Powers Engineering

Subject: Powers Engineering comments on EPA 316(b) March 28, 2011 TDD

This comment letter summarizes my review of the EPA's March 28, 2011 Technical Development Document for the Proposed Section 316(b) Phase II Existing Facilities Rule (2011 TDD). The Powers Engineering review addresses the reasonableness of cooling tower retrofit capital costs identified by the EPA, projected turbine efficiency penalties and cooling tower parasitic fan and pump loads imposed by cooling towers, cooling tower retrofit downtime, air pollution impacts, cooling tower space requirements, uncertainties regarding useful remaining plant life, permit application requirements, and related issues.

Figure 1. Cooling Tower with 10 °F Approach Temperature Is 25 Percent Larger than Tower with 13 °F Approach Temperature¹⁵

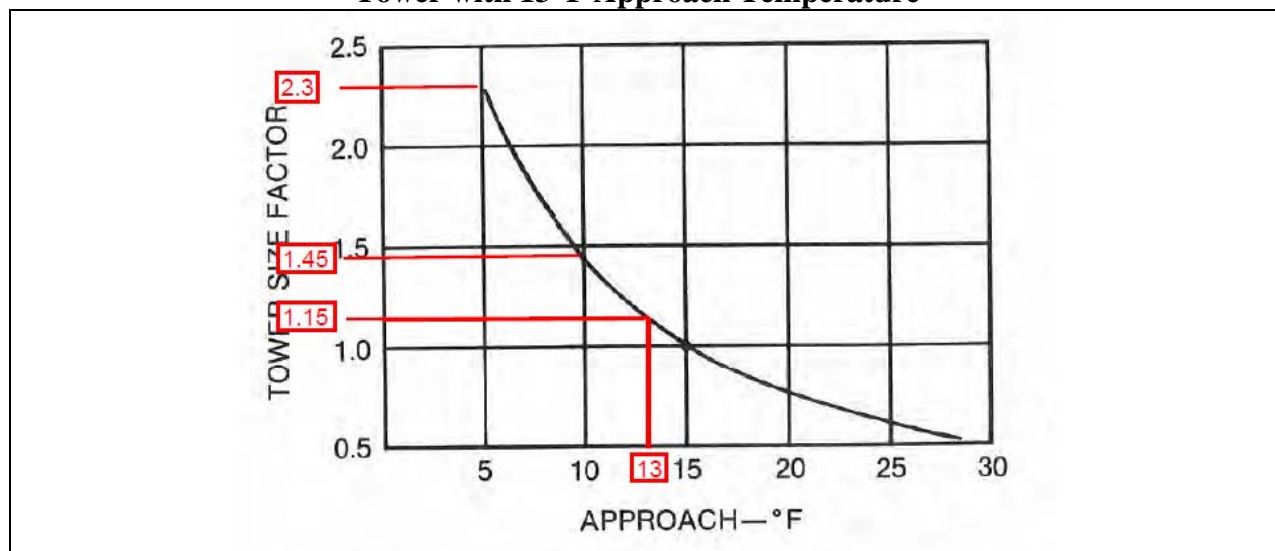
specifications for actual cooling towers lists fifteen towers at or above a flowrate of 100,000 gpm.¹⁴ Six of these towers are located in the Southeast. Nine towers are located in other parts of the country. The average approach temperature of the six cooling towers in the Southeast is 8.7 °F. The average approach temperature of the nine cooling towers located in other parts of the country is 12.6 °F. Figure 1 shows the effect of cooling tower design approach temperature on the size of the cooling tower.

For the purpose of calculating the nationwide cost of plume-abated cooling towers, it is assumed in this comment letter that 25 percent of the plume-abated cooling tower retrofits would occur in the Southeast and would be designed for a 8 °F approach temperature. Cooling towers for other areas of the U.S. would be designed for a 12 °F approach temperature. Cooling towers in the Southeast would be about 30 percent larger than cooling towers in the rest of the country for the same circulating water flowrate, as determined in **Attachment B**. All of the plume-abated units are assumed to utilize a compact, back-to-back design.¹⁶

Figure 2. Reduction in MW Output from Indian Point Nuclear Unit 2 as Hudson River Temperature Increases³⁶

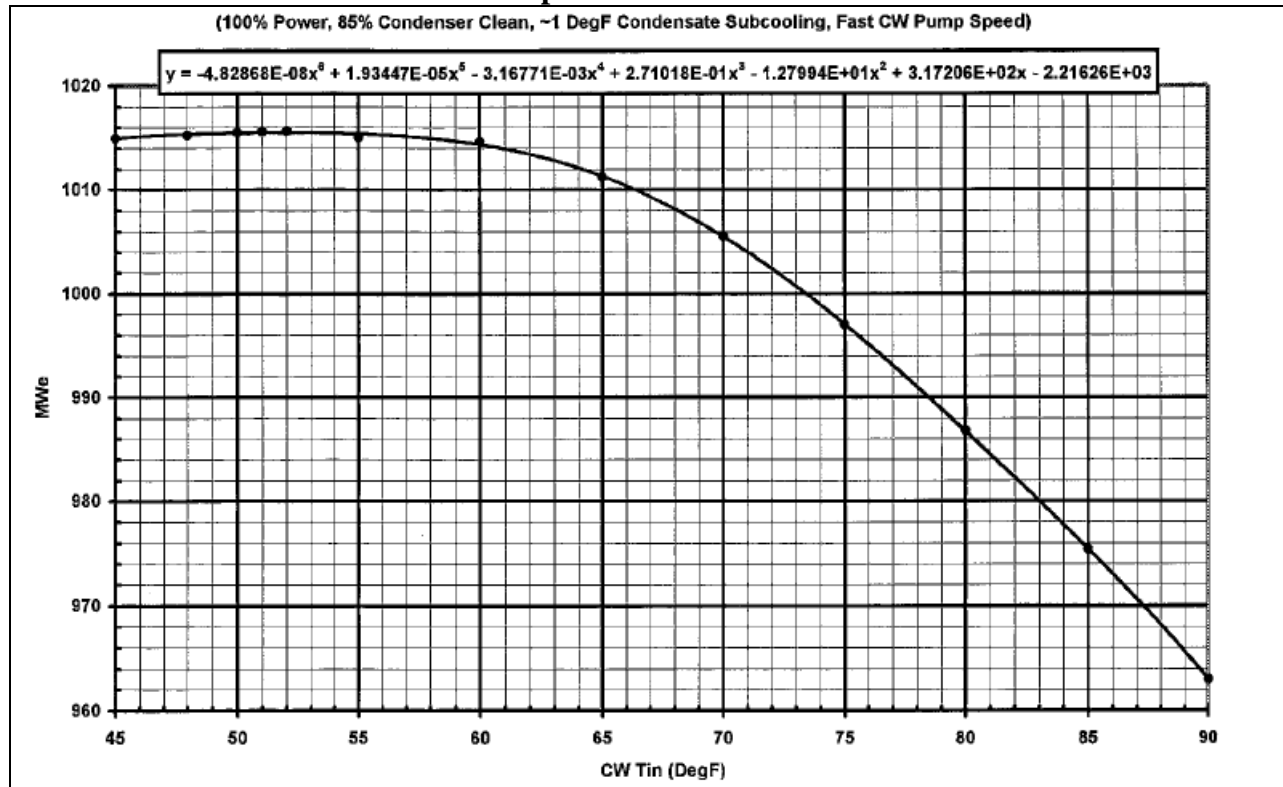
This phenomenon is shown in Figure 2 for Unit 2 at the Indian Point Nuclear Generating Station (Indian Point). The output of Indian Point Unit 2 drops from 1,015 MW at a river temperature of 55 °F to 983 MW at 82 °F. This is a 3.4 percent drop in output due to the turbine efficiency penalty experienced by the existing OTC cooling system as the river temperature rises to its maximum monthly level.

The owner of Indian Point, Entergy Nuclear, determined the month-to-month turbine efficiency penalty of a cooling tower conversion on MW output from Indian Point Units 2 in its analysis of the feasibility and cost of such a conversion.³⁷ Powers Engineering has overlaid curves showing the decline in MW output of the existing OTC-cooled Units 2 and 3 caused by increasing Hudson River water temperature on the cooling tower turbine efficiency penalty curves prepared by Entergy Nuclear.³⁸ This data is presented in **Attachment D**.

Figure 5. Comparison of Siting Requirements – Back-to-Back Versus In-Line Cooling Towers⁷⁷

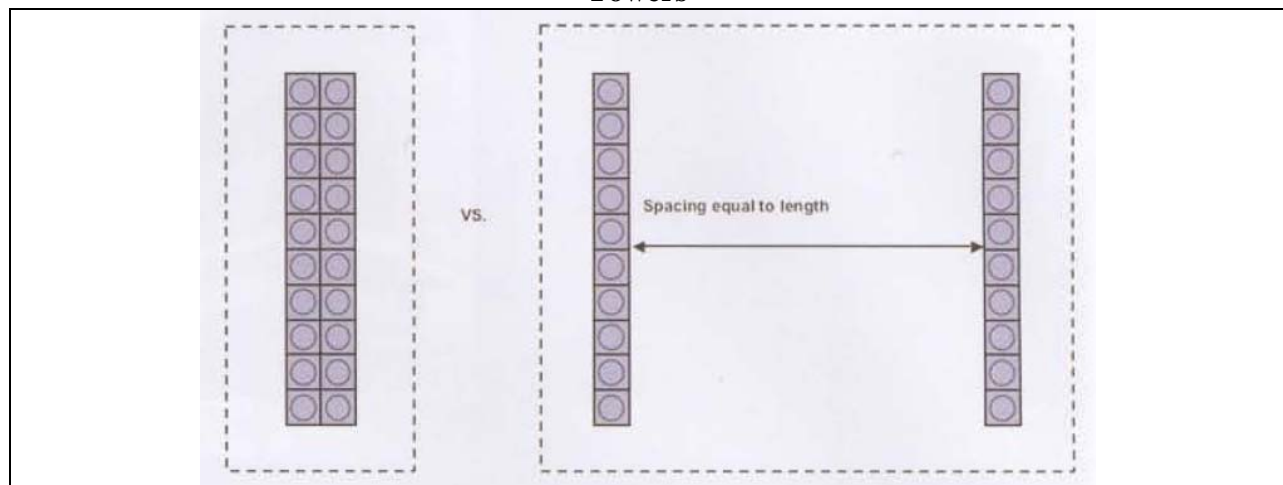
Figure 5 shows a comparison of site requirements for two in-line towers compared to one back-to-back tower that provides the same cooling capacity. The back-to-back cooling tower requires about 17 percent of the space needed for two in-line towers, assuming the spacing recommended for parallel banks of in-line towers. The recommended in-line tower spacing is for the distance between the towers to equal the length of the towers, as shown in Figure 5.

EPA should not attempt to set any “acreage-to-MW” rule-of-thumb that would presumptively exempt large numbers of plants from installing retrofit cooling towers. EPA did not consider the one cooling tower technology specifically intended for constrained sites – back-to-back cooling towers – in its analysis of cooling tower space requirements. Back-to-back cooling towers require only 17 percent the space of the in-line cooling towers evaluated by the EPA in its consideration of a “limited space exemption” threshold of approximately 160 acres per 1,000 MW. This threshold would drop to approximately 27 acres per 1,000 MW if the cooling tower configuration assumed is back-to-back.⁷⁸

Figure 6. Examples of Operational U.S. Back-to-Back Cooling Towers and ClearSky Cell

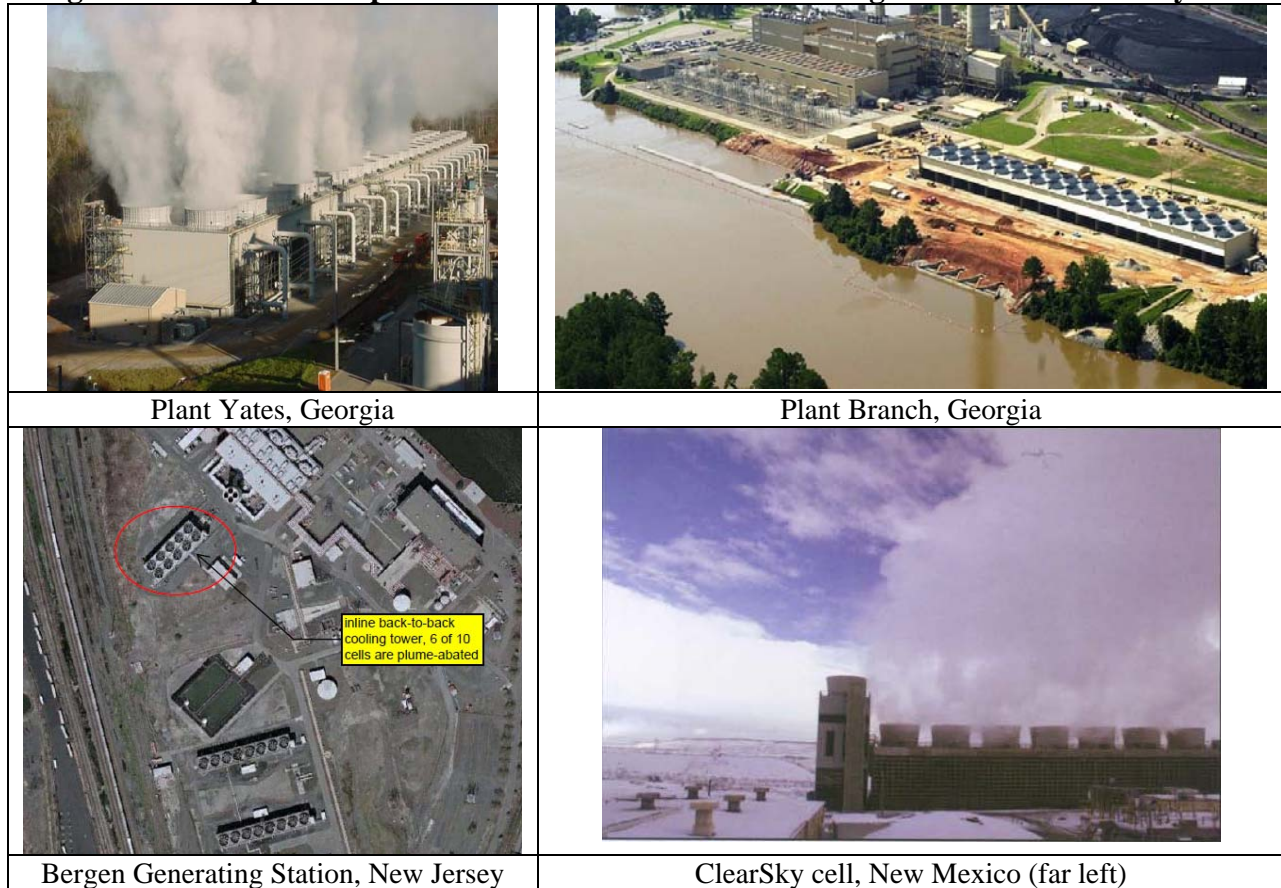
Back-to-back cooling towers, both wet and plume-abated, are in commercial use in the U.S. Figure 6 provides examples of operational back-to-back cooling towers and a ClearSky™ cell in operation in New Mexico.
